From: [Hurst, Benjamin M](#)
To: [Wilson, Aimee](#)
Cc: [Kovacs, Jeffrey K](#)
Subject: RE: Draft Permit and Statement of Basis - For Your Review
Date: Friday, May 03, 2013 3:29:07 PM
Attachments: [2013.05.03 Comments to EPA.pdf](#)

Comments to Draft GHG Permit PSD-TX-102982-GHG

ExxonMobil Chemical Company

Ethylene Expansion Project

Figure 2-1

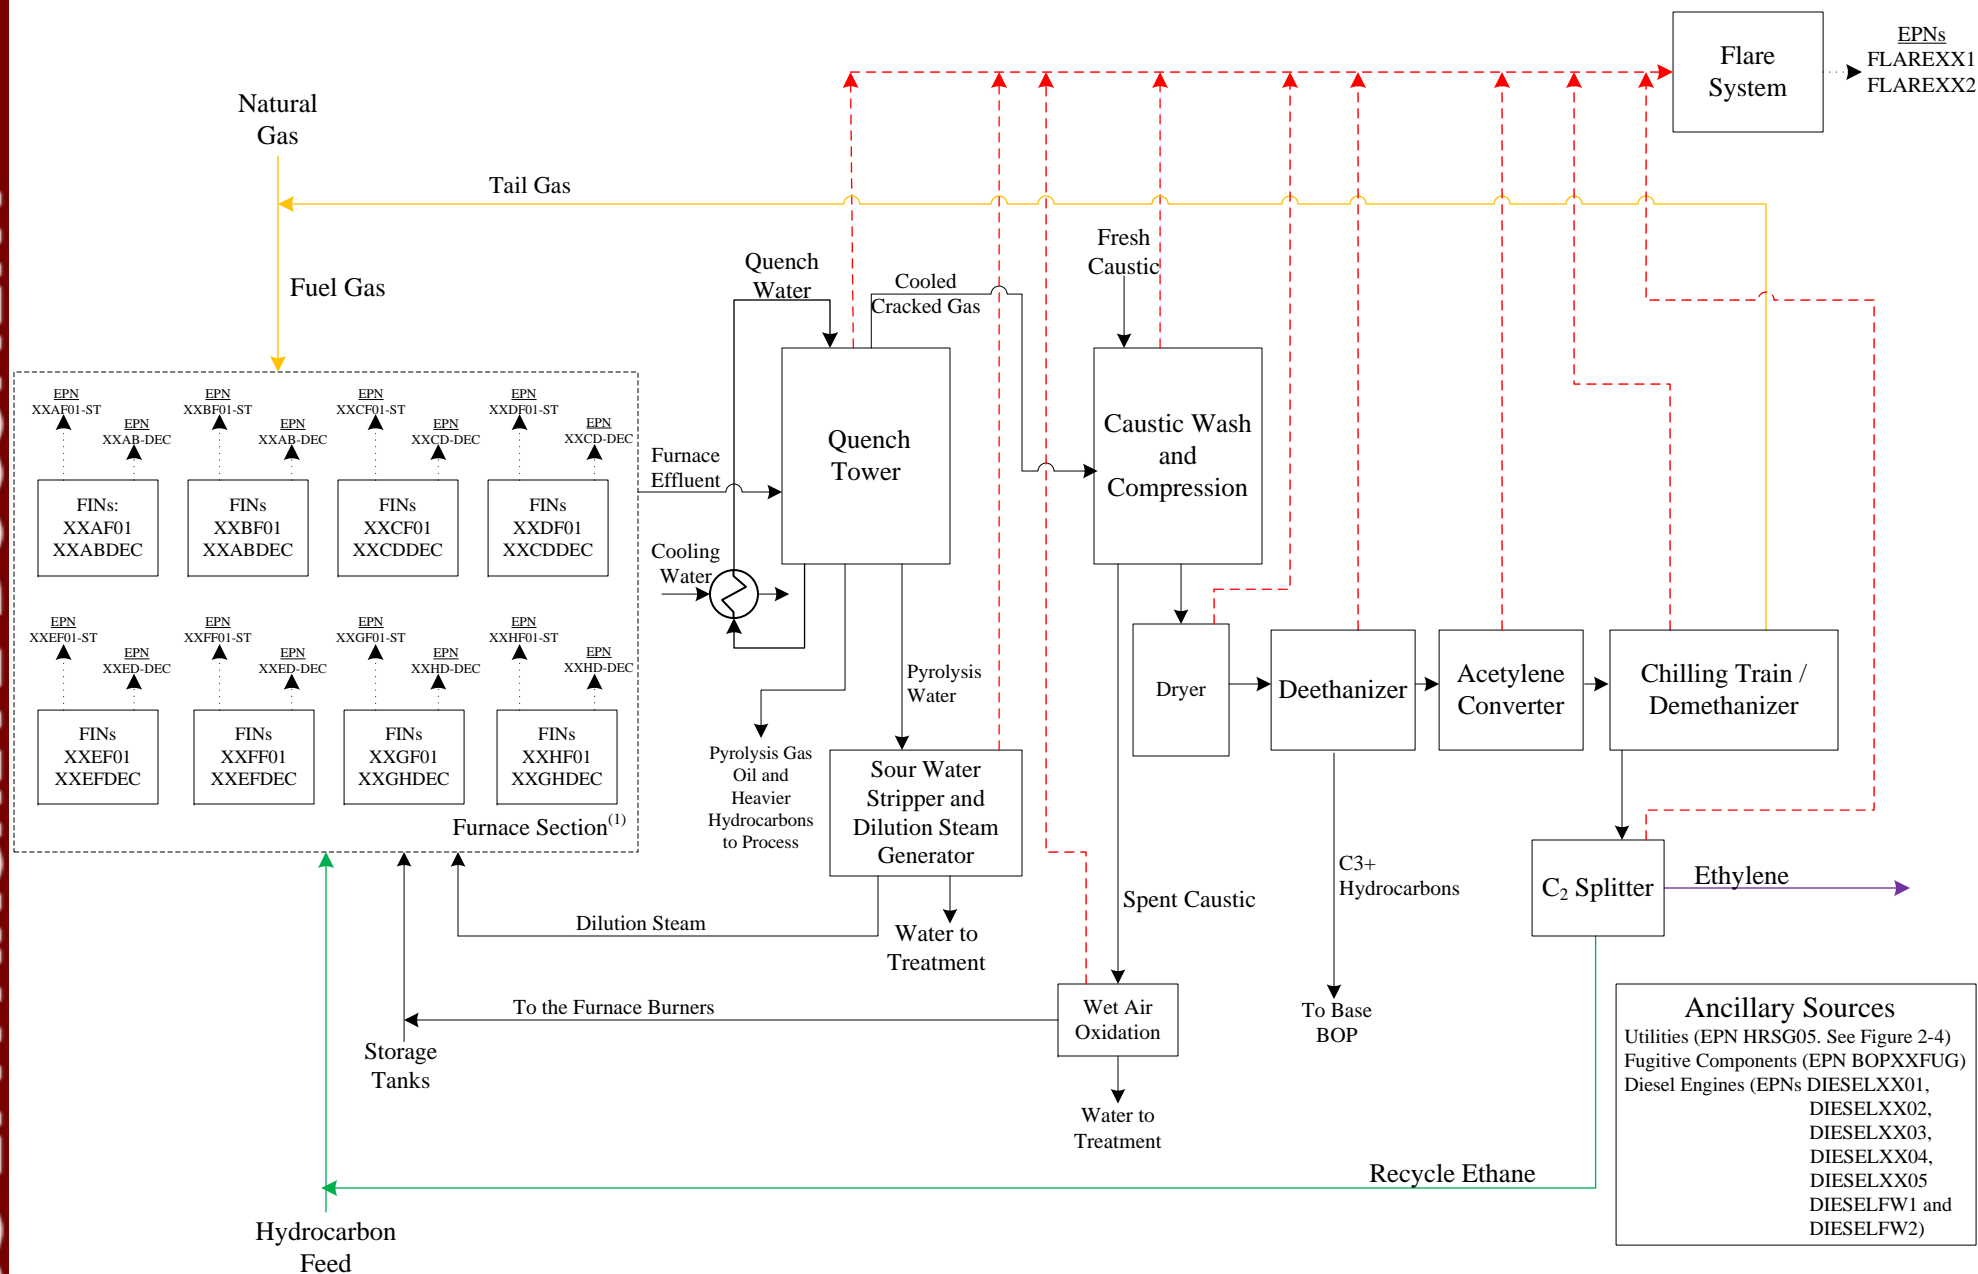
4. The design for the proposed project will use acetylene converters to convert acetylene to ethylene and ethane using the hydrogen already present in the acetylene containing stream. This type of acetylene converter technology does not use online catalyst regeneration, rather the catalyst is replaced, if needed, during an entire plant shutdown / turnaround. As such, there will no longer be GHG emissions from regeneration of the acetylene converter. Therefore, we request that all references, conditions, emission limits, etc. related to EPN ACETCONVXX in the draft permit be removed. The process flow diagram (Figure 2-1) reflecting this configuration is included in Attachment 1 of this document.

Please consider this information in finalizing the Equipment List, Table 1, and Conditions III.A.2., III.B.1., V.A., and V.D.
